**Ref: Section 5 Appeal (Exempted Planning) on Behalf of Diarmuid Breen
Against the Decision of Kerry Co. Co. to refuse to Declare
Development of Agricultural Storage Shed of a less than 300m² in area, Exempted Planning
Site at Ardmore, Sneem, Co. Kerry
Kerry County Council File Ref. No. EX 885**

Section 5 Appeal Against Decision of Kerry County Council

Stage 1/2 Road Safety Audit

Summary Traffic Assessment

Figure 3 –Site Layout Plan showing access with the N70

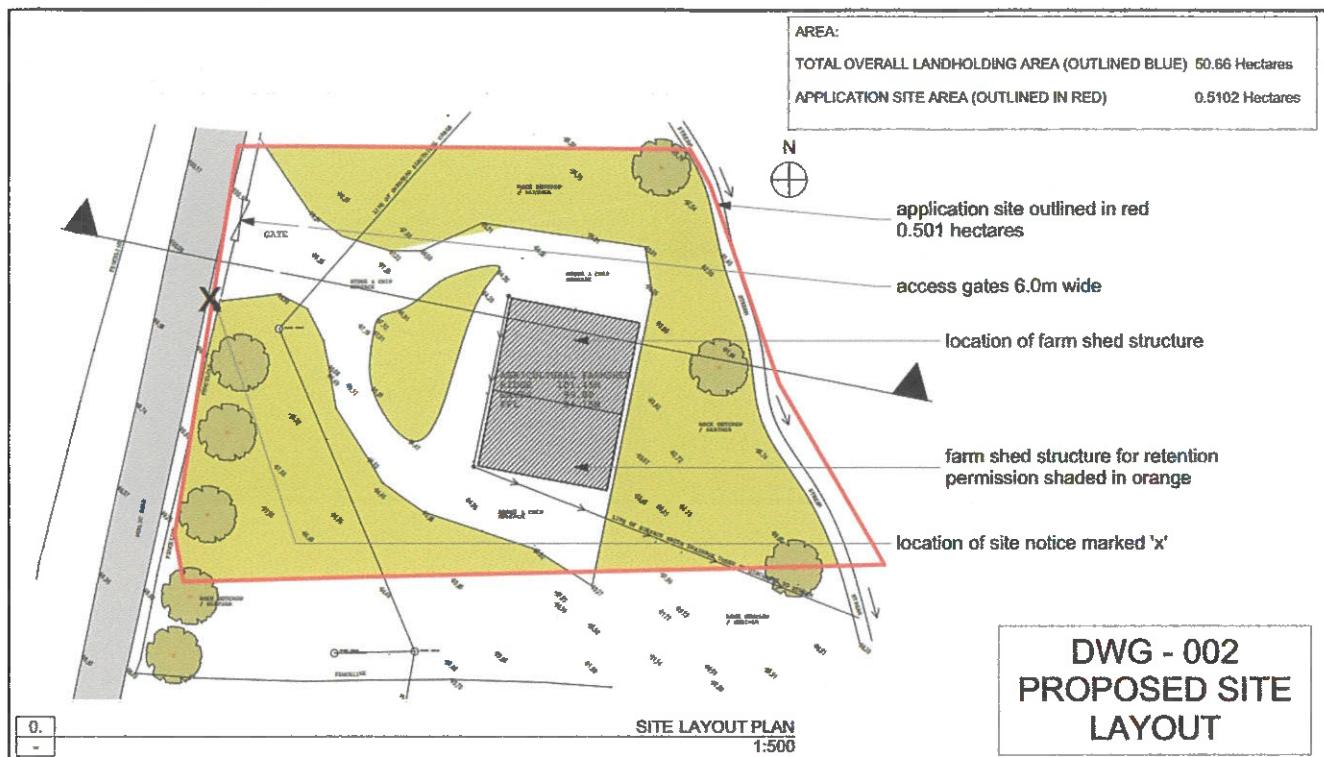
2.1. Problem: Inadequate Sightlines at existing junction

The Junction from the Development is within the posted speed limit of 80Km/hr. The Design Manual for Road and Bridges requires sightlines of 160m in both directions at a 3.0m setback. Refer to photo 1 & 2 in Appendix A, showing the existing sightlines at 3.0m setback. Inadequate Sightlines at a junction may lead to collisions between vehicles using the N70 and vehicles exiting the development or decelerating to enter the development access.

2.2. Problem: Lack of Road Drainage Proposals

Road surface water drainage proposals are not shown on the drawings provided to the audit team. Currently the surface water on the N70 falls towards the gravel access with some visible water ponding present at the time of the site visit. Lack of adequate roadside surface drainage could lead to surface water ponding on the road carriageway. This could result in collisions between vehicles or between vehicles and cyclists/pedestrians due to aquaplaning on water ponds following heavy rainfall. Also, ice on the road during cold weather conditions presents a severe road safety hazard to consider. In addition, surface water ingress/ponding could lead to long term damage to the N70 road formation. Refer to photo 3 in Appendix A.

2.3. Problem: Lack of Road Markings

No road markings details have been provided at the entrance onto the N70. Inadequate road markings could lead to collisions involving vehicles exiting the storage facility due to vehicles not adequately stopping and checking for oncoming traffic prior to turning onto the N70.

Recommendation 1

The proposed junction should have the adequate visibility envelope, in compliance with the design standards as outlined in the Design Manual for Road and Bridges (DMRB) for the road design speed. This envelope should be kept clear of all obstructions such as walls, fences etc and vegetation over 600mm in height.

Recommendation 2

Provide road surface water drainage along the site frontage at the proposed entrance onto the N70.

Recommendation 3

Provide adequate stop road markings at the proposed junction with the N70.
